RE; MWRA Contract No. 6840 East Boston Branch Sewer.
Changed Condition ITI COR 11

Subj: **Pipe Preparation at Stations 10+23 and 20+93: East Boston Branch Sewer Rehabilitation,**
MWRA Contract No. 6840

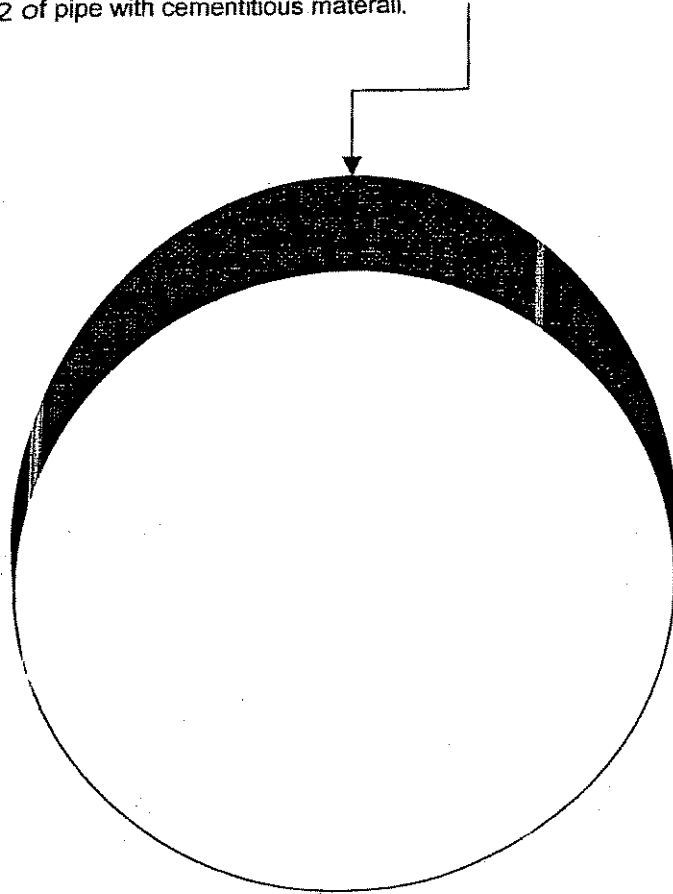
As we discussed yesterday, based on our field measurements and observations the pipe was constructed with a taper on the downstream side of the manhole at station 20+93. A similar situation appears to be the case (although to a lesser extent) at manhole 10+23; however, additional measurement and investigation following bypass startup and initial cleaning is advised.

At manhole 20+93 we recommend that the taper area be "filled" with 4" to 6" of cementitious material at the crown prior to lining to bring it to 39.2" (minus zero, plus ½") equivalent diameter. The material should be applied only in the top half of the pipe to provide a smooth and circular shape as generally depicted in the attached drawing.

Fill top 1/2 of pipe with cementitious material.

Maintain existing flow line.
